Access Compliance Report

Public Rights-of-Way

Intersection ID: 16581	Main Street: MEADOWDALE_LN	Cross Street: DAWNWOOD_DR	Location:	NW
ADA ID: 3C103FA3C89E	Ramp Type: BlendTrans2	Initial Pass/Fail: Fail	Overall Compliance: No	Severity Score: 25

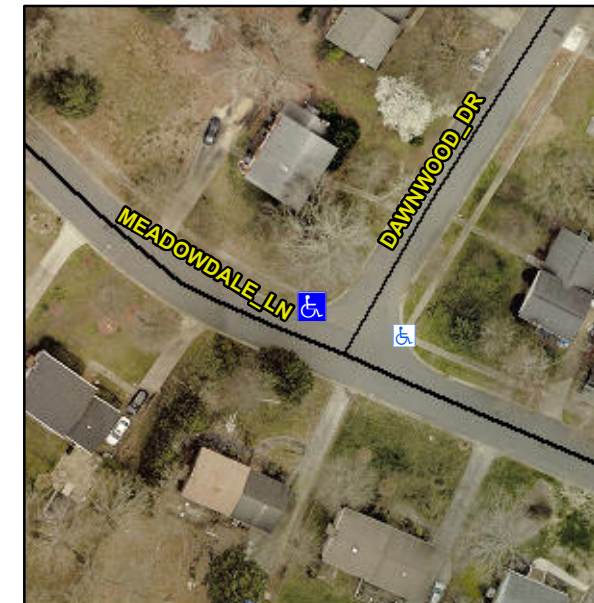
Not Found, R304.5.3

Compliance	Description	Data	Compliance	Description	Data
N/A	Ramp Length (in)	29.0	Yes	BlendTrans Slope (%)	2.0
Yes	Ramp Width (in)	48.0	No	BlendTrans XSlope (%)	10.0
N/A	Flare Type LT	N/A	N/A	Flare Type RT	N/A
N/A	Flare Slope LT (%)	N/A	N/A	Flare Slope RT (%)	N/A
N/A	Flare Traversable LT?	N/A	N/A	Flare Traversable RT?	N/A
N/A	Landing Length (in)	N/A	N/A	DWS Provided?	N/A
N/A	Landing Width (in)	N/A	N/A	DWS Contrast?	N/A
N/A	Landing Slope (%)	N/A	N/A	DWS Length (in)	N/A
N/A	Landing X Slope (%)	N/A	N/A	DWS Full Width?	N/A
N/A	Landing Curb? (Y/N)	N/A	N/A	DWS Offset (in)	N/A
N/A	Shared Landing?	N/A			
N/A	Gutter Ponding?	N/A	N/A	Gutter Slope (%)	N/A
N/A	Gutter Lip Ht (in)	N/A	N/A	Gutter X Slope (%)	N/A
N/A	Painted X Walk1?	No	N/A	Painted X Walk2?	No
	X Walk 1 Direction	To SW		X Walk 2 Direction	To SE
	X Walk 1 Width (in)	N/A		X Walk 2 Width (in)	N/A
	X Walk 1 Slope (%)	3.4		X Walk 2 Slope (%)	10.1
	X Walk 1 X Slope (%)	8.8		X Walk 2 X Slope (%)	4.5

Remove & Replace Curb Ramp With Two New Directional Ramps or Equivalent.
